NATIONAL TRANSPORTATION SAFETY BOARD

**Group Chairman's Aircraft Performance Study Addendum #1
by John O'Callaghan**

Location:	Belle Harbor, New York
Date:	November 12, 2001
Time:	09:17 AM Eastern Standard Time (EST)
Flight:	American Airlines Flight 587
Aircraft:	Airbus A300B4-605R, Registration N14053
NTSB#:	DCA02MA001

Figure 3.

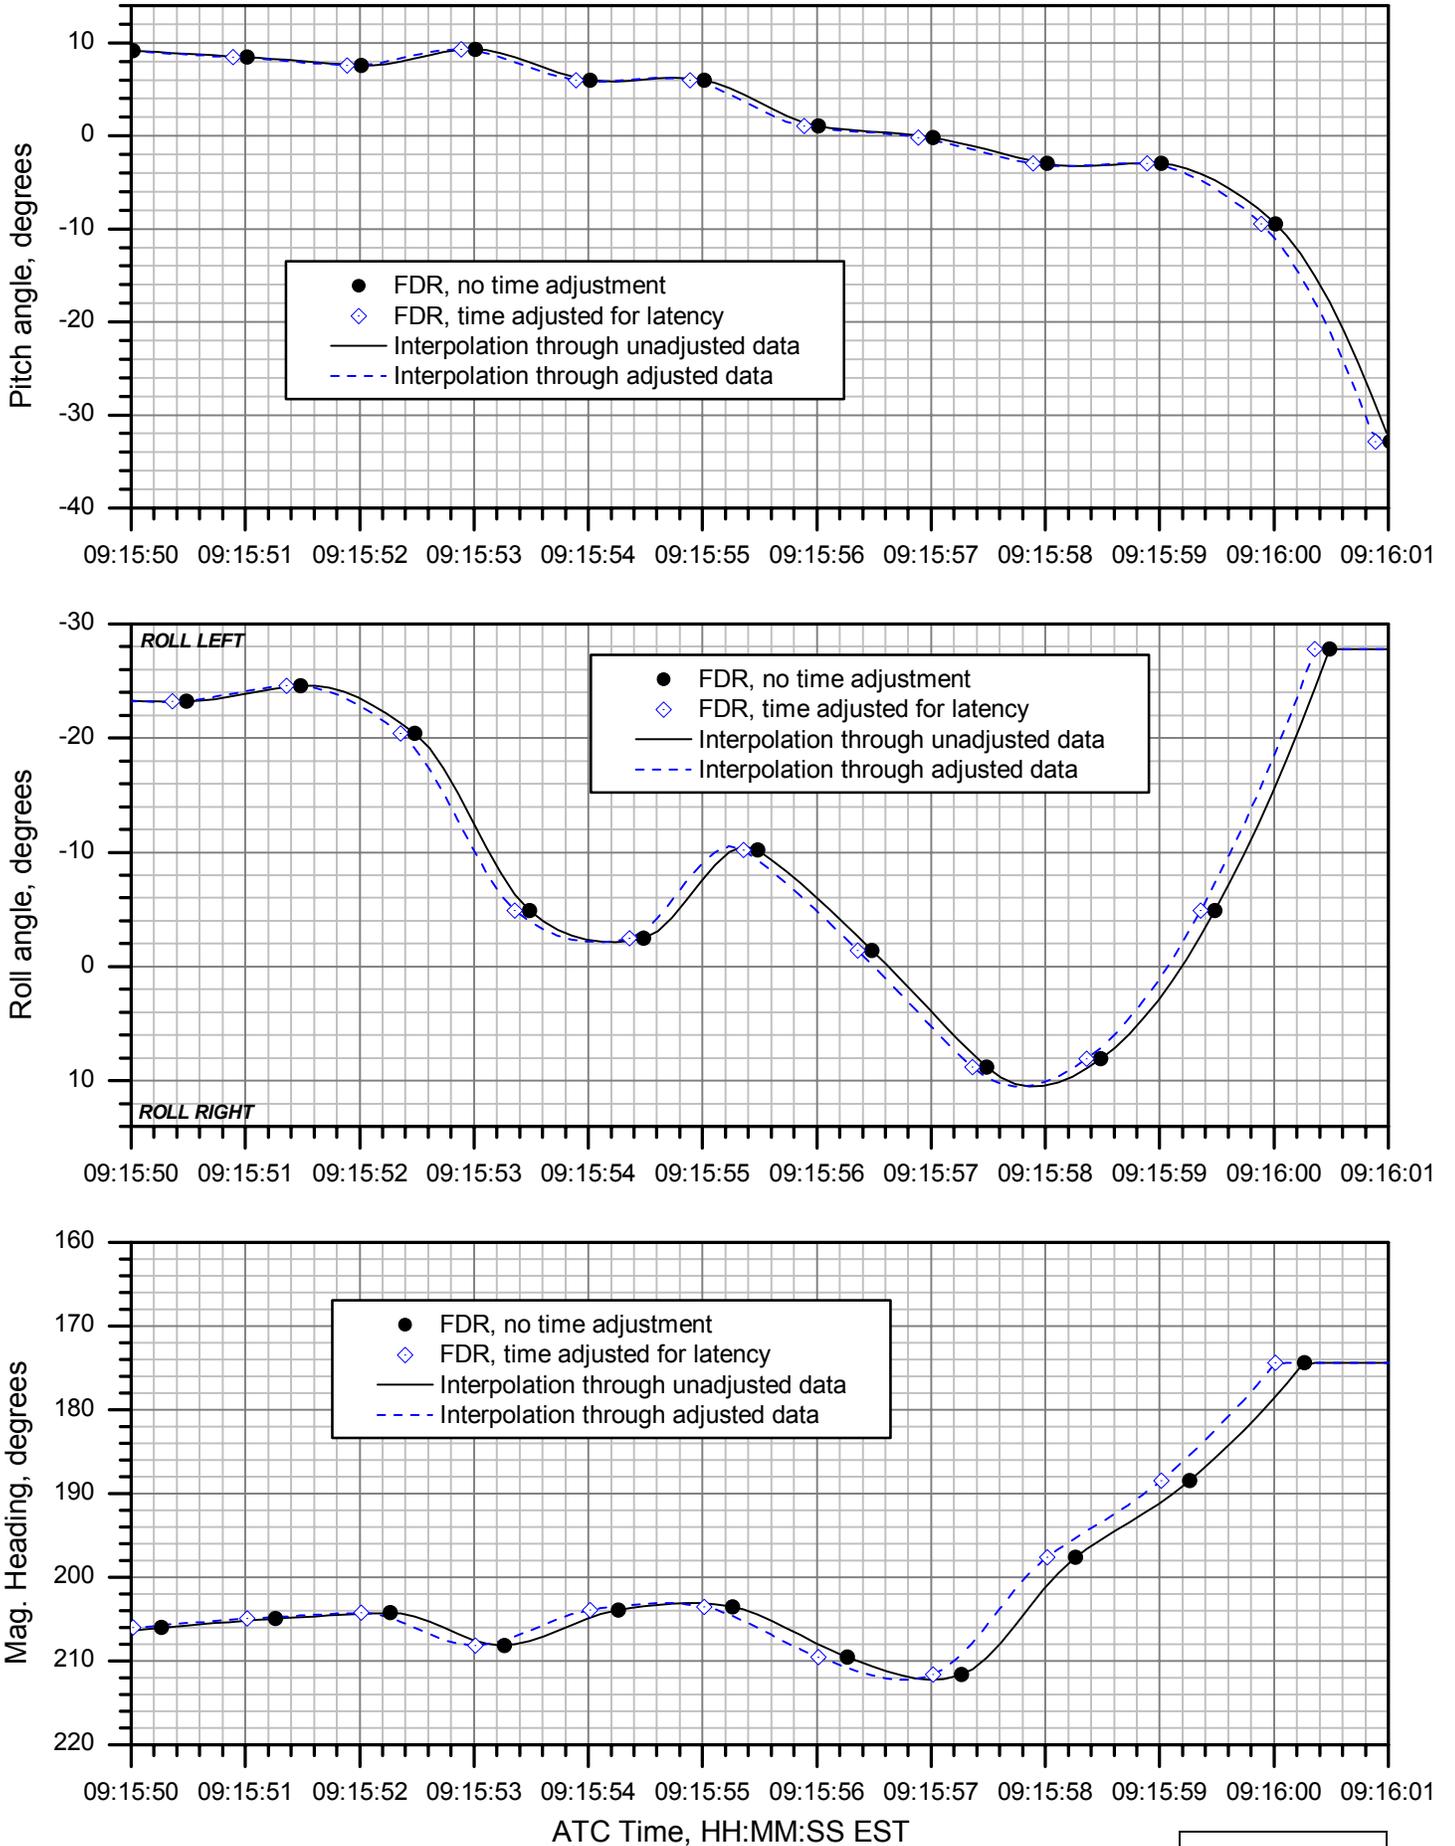
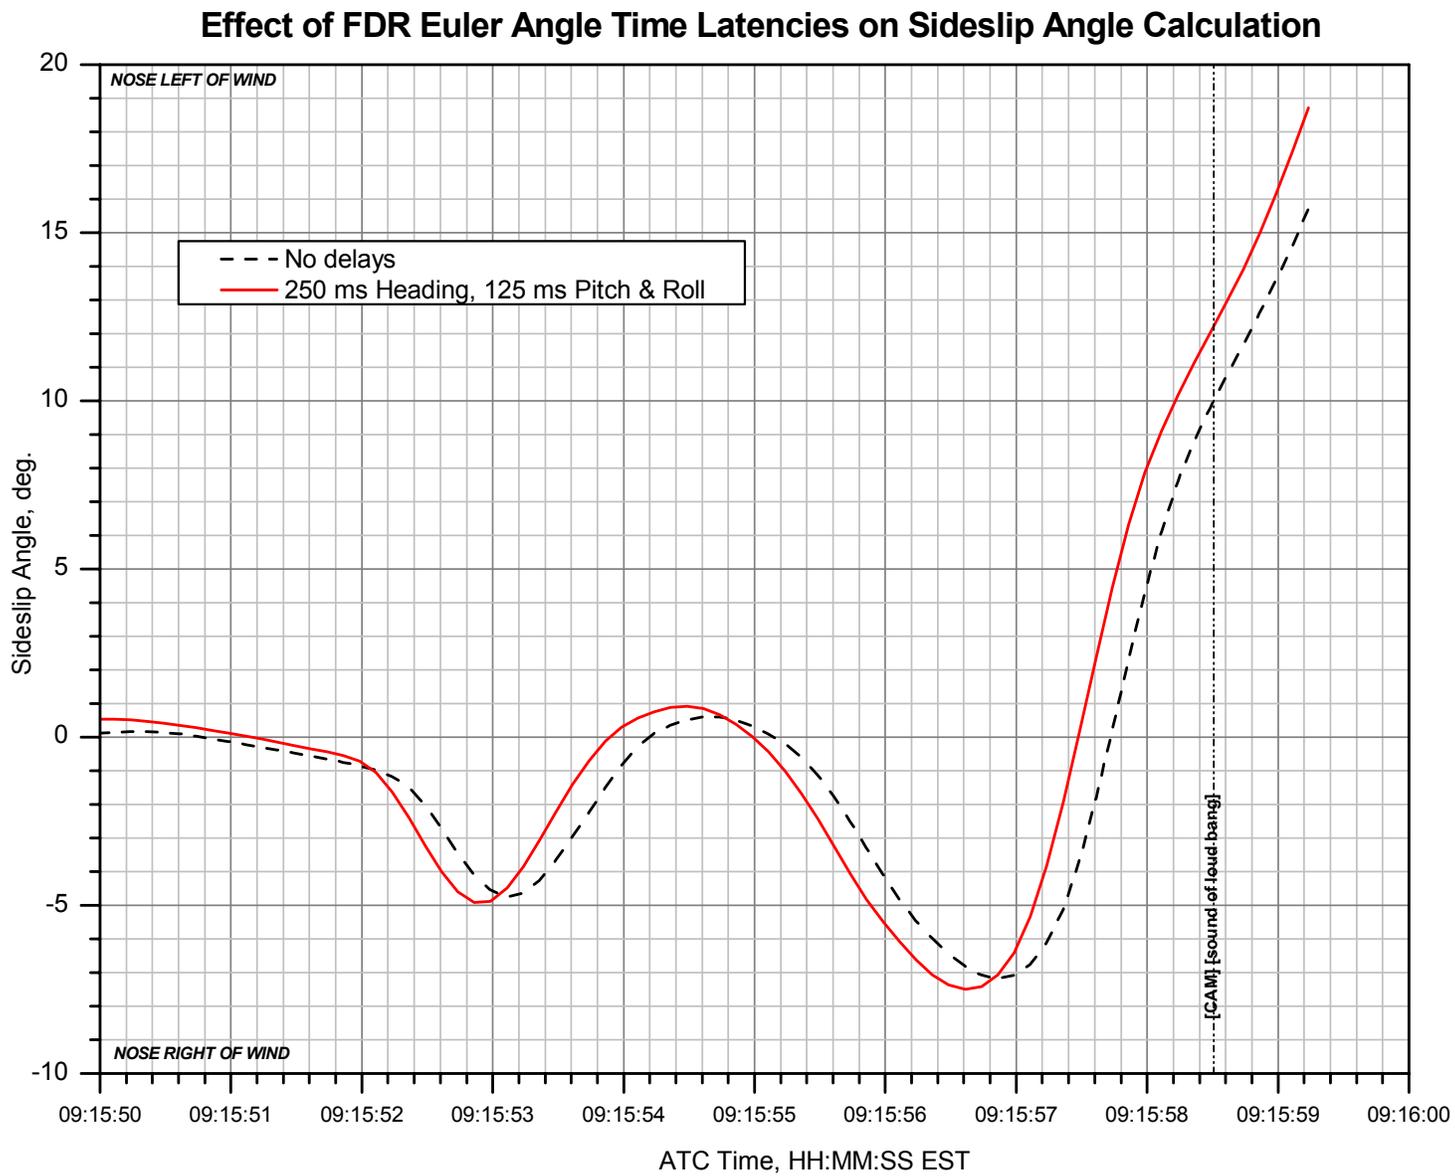
The Euler angles adjusted for data time latencies as described in Section 2.1 are shown in Figure 2, along with the unadjusted FDR data[10]. The sideslip angle calculated using the adjusted Euler angles is shown in Figure 3. The original sideslip angle, computed without any adjustments to the Euler angles, is also shown. Not surprisingly, the effect of the 250 ms adjustment to Magnetic Heading is to advance the computed sideslip angle in time by about a quarter second. As a result, at the approximate time of the tail separation (about coincident with the "loud bang" sound recorded on the CVR), the updated sideslip angle is about 2° higher than the original. The uncertainty in the sideslip angle calculation and resulting tail loads associated with various combinations of the full range of possible data latency values is still under investigation.
